Proposal #08: 5098-00-72
STH 23 – Rock Springs
STH 23 to Village Limits
STH 154
Sauk County

This is Addendum No. 01, which provides for the following:

ADDENDUM NO. 01

Addendum No. 01
 ID 5098-00-72
 Revised sheet 8
 March 3, 2017

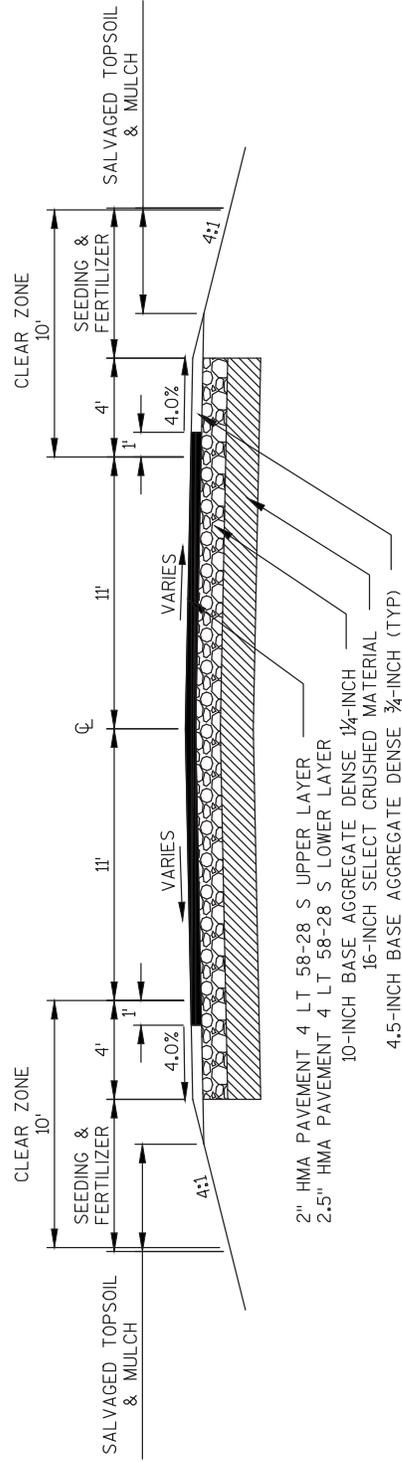
Revised Plan Sheets	
Plan Sheet	Plan Sheet Title (brief description of changes to sheet)
8	Finished Typical Sections (added note about lower layer thickness)
41	Miscellaneous Quantities (revised Removing Asphaltic Surface Milling item)
43	Miscellaneous Quantities (revised HMA Pavement 4 LT 58-28 S item)

*PAVE 3" HMA PAVEMENT 4 LT 58-28 S LOWER LAYER,
 THEN MILL 0.5' IN OVERALL PROJECT MILLING OPERATION
 TO OBTAIN FINAL 2.5" LAYER THICKNESS.
